UNITED STATES PATENT AND TRADEMARK OFFICE

10/582,809

Mitsuhiro Mori

DETAILED ACTION

Detail from Woodling (US 2,376,566)

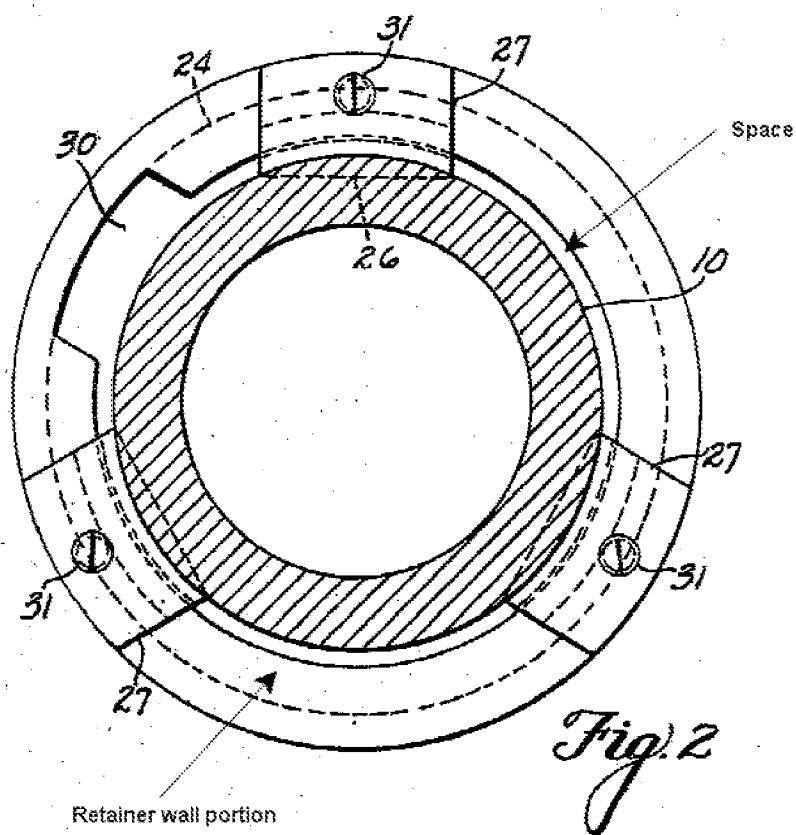
As to claim 1, Woodling teaches a pipe joint construction comprising an elastic seal member (17) for hermetically sealing between an inner circumferential surface (annotated Fig. 4, Examiner's Appendix [EA]) of a receiving pipe section (33) and an outer circumferential surface (Fig. 4, EA) of an inserted pipe section (10) inserted into and connected to the receiving pipe section (33) in a pipe axis direction (left-right, Fig. 4),

and a lock member (left-hand radially extending portion of U-shaped member 35; Fig. 4, EA) provided interior to the inner circumferential surface (at top of groove 34) of the receiving pipe section (33) adjacent a receiving opening thereof (Fig. 2, inner perimeter of outer pipe) for preventing separating movement of the pipe sections by contacting an engaging projection (Fig. 4, EA) protruding from the outer circumferential surface of the inserted pipe section (where outer surface of 10 protrudes above the groove 36) in the pipe axis direction,

As to claim 2, Woodling teaches the pipe joint construction as above for claim 1, further comprising a stopper wall portion (annotated Fig. 4, EA) formed in the inner circumferential surface of the receiving pipe section (33) at a portion close to the receiving opening from a seal mounting groove (19) for receiving the elastic seal member (17) to contact an engaging projection (Fig. 4, EA) protruding from the outer circumferential surface (the groove of 10 at 36) of the inserted pipe section in the pipe axis direction, thereby to limit a maximum contracting position between the pipe sections (the stopper wall formed in the end cap of 33 limits the axial movement of 10).

As to claim 4, Woodling teaches wherein the split lock pieces (Fig. 4, EA) are formed on outer circumferential surfaces (bottom surface of U-shaped element 35 is the circumferential surface) of the control members (35) with engaging portions (sloped surface 38) extending beyond an inner diameter of the receiving opening of the receiving pipe section (Fig. 4, EA, bottom of retainer wall portion; Fig. 2, inner perimeter of outer pipe).
